**MONTGOMERY COUNTY HISTORIC PRESERVATION COMMISSION**  
**STAFF REPORT**

<b>Address:</b>	29 Hesketh St., Chevy Chase	<b>Meeting Date:</b>	5/21/2019
<b>Resource:</b>	Contributing Resource <b>Chevy Chase Village Historic District</b>	<b>Report Date:</b>	5/14/2019
<b>Applicant:</b>	Elizabeth Delgard	<b>Public Notice:</b>	5/7/2019
		<b>Tax Credit:</b>	N/A
<b>Review:</b>	HAWP	<b>Staff:</b>	Michael Kyne
<b>Case Number:</b>	35/13-19P		
<b>PROPOSAL:</b>	Window and door alterations

# 1 ELEVATION SUNROOM

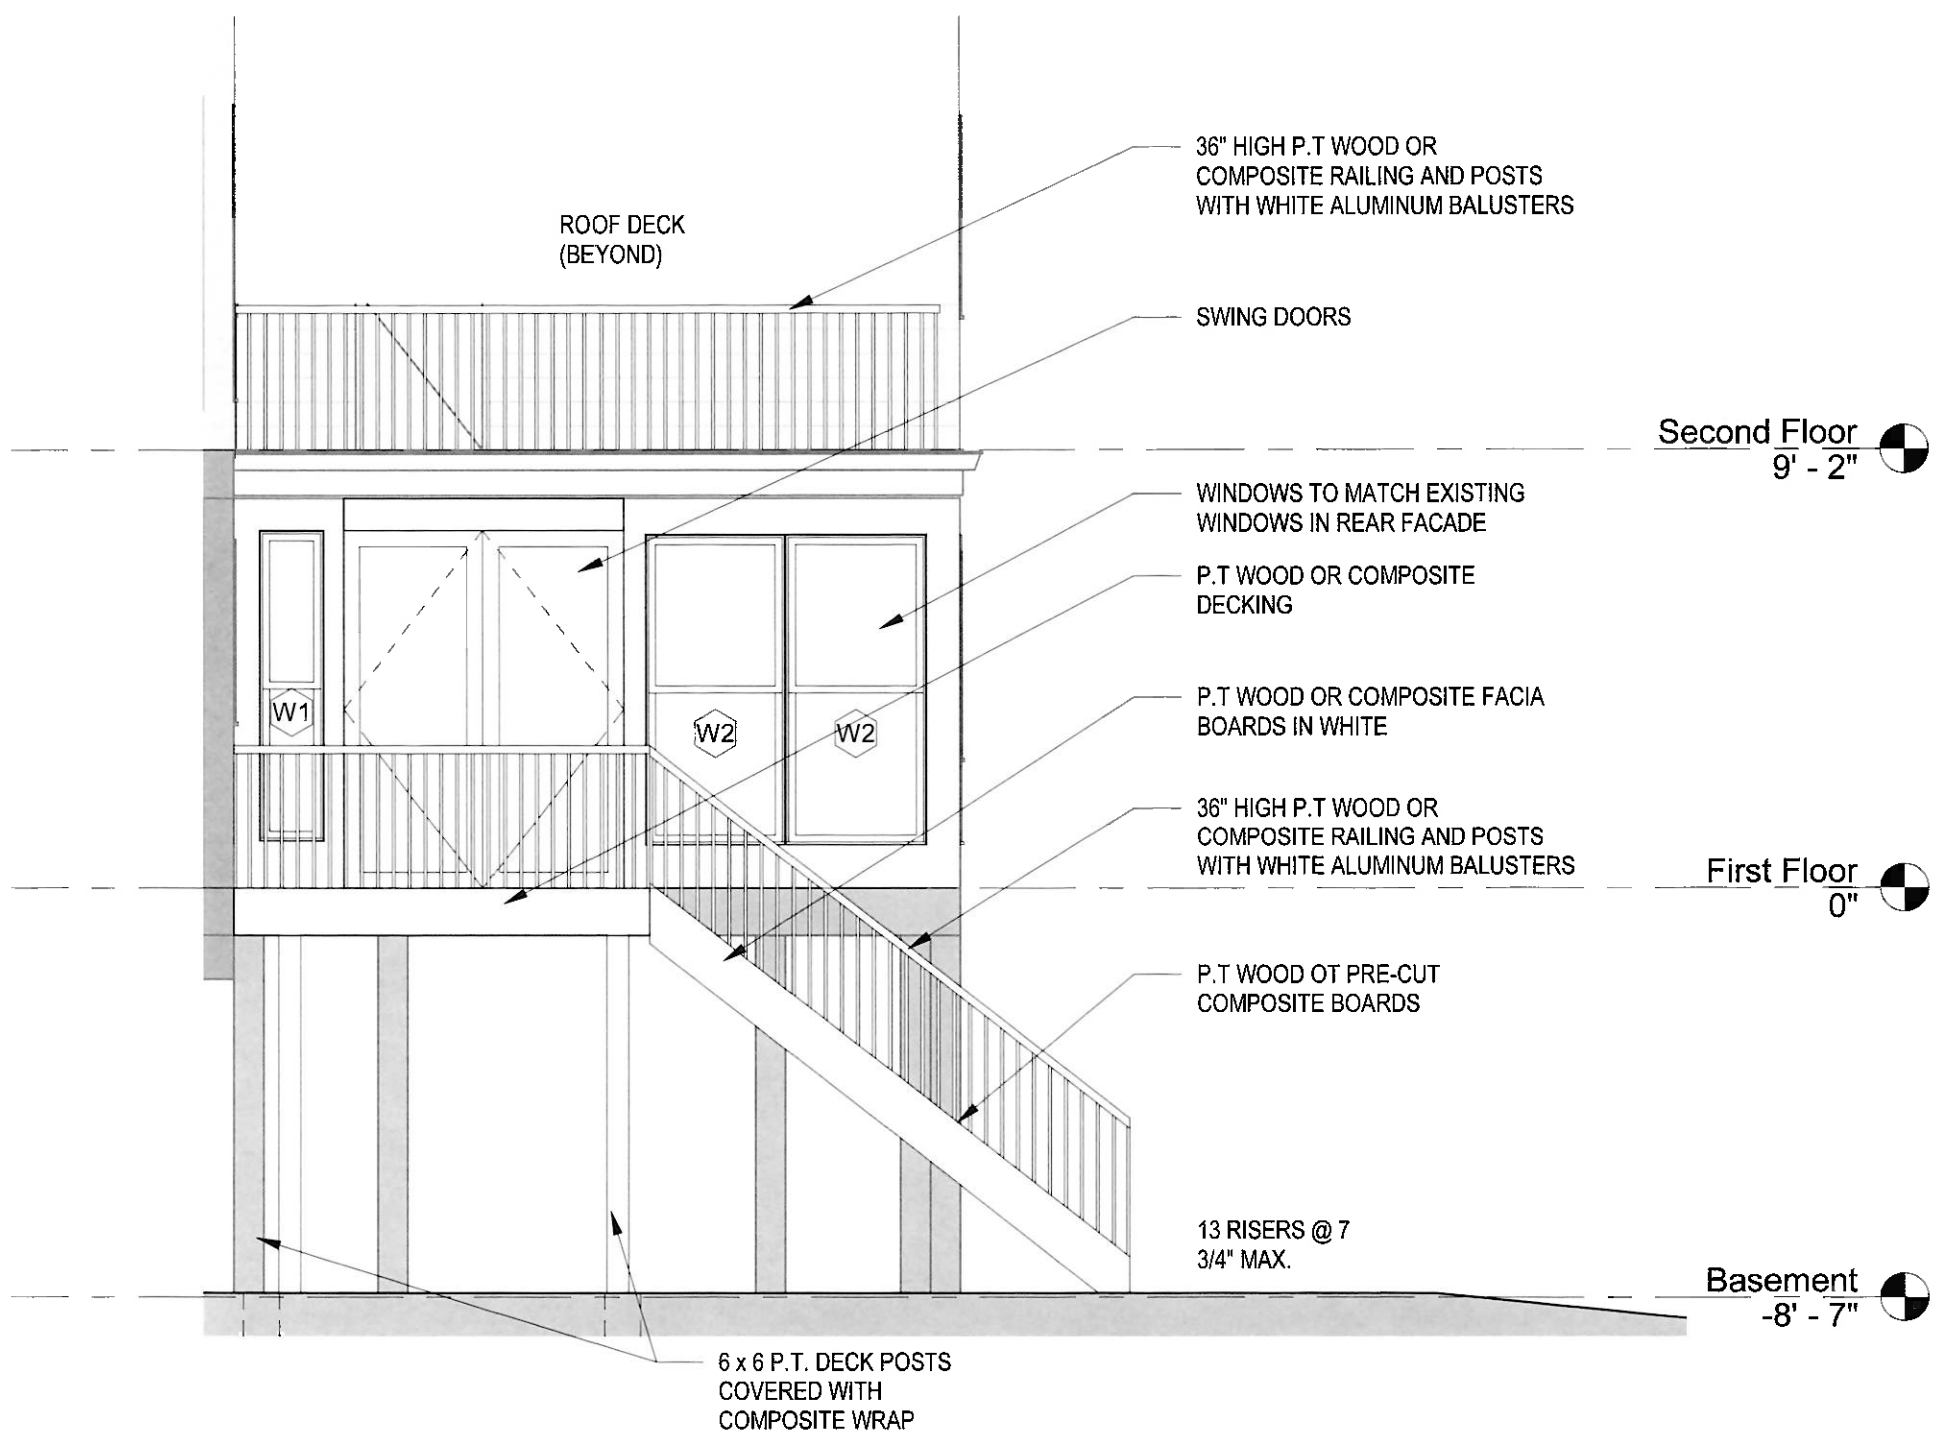
The existing doors of the mudroom are sliding doors, and the proposed replacement windows will be one-over-one vinyl windows to match existing windows on the rear of the historic house. The proposed stairs will be wood or composite, with wood or composite trim. The proposed railings will be wood or composite, with white aluminum balusters.

Staff finds that, in order to preserve the integrity of the resource, the proposed materials should be compatible with the historic house and surrounding streetscape. Accordingly, staff finds that the proposal should utilize traditional materials or appropriate alternatives, with finishes and aging that is consistent with traditional materials (i.e., wood or appropriate aluminum-clad wood windows, wooden railings with balusters inset between the top and bottom rails, and wooden stairs and trim). Staff recommends the following conditions of approval, ensuring that the proposal will not alter character-defining features of the surrounding historic district, in accordance with the *Standards*:

1. **The proposed windows will be wood, not vinyl, with final review and approval delegated to staff.**
2. **The proposed railings and balusters will be wood, not composite or aluminum, with final review and approval delegated to staff.**
3. **The proposed stairs and trim will be constructed from wood, not composite materials, with final review and approval delegated to staff.**
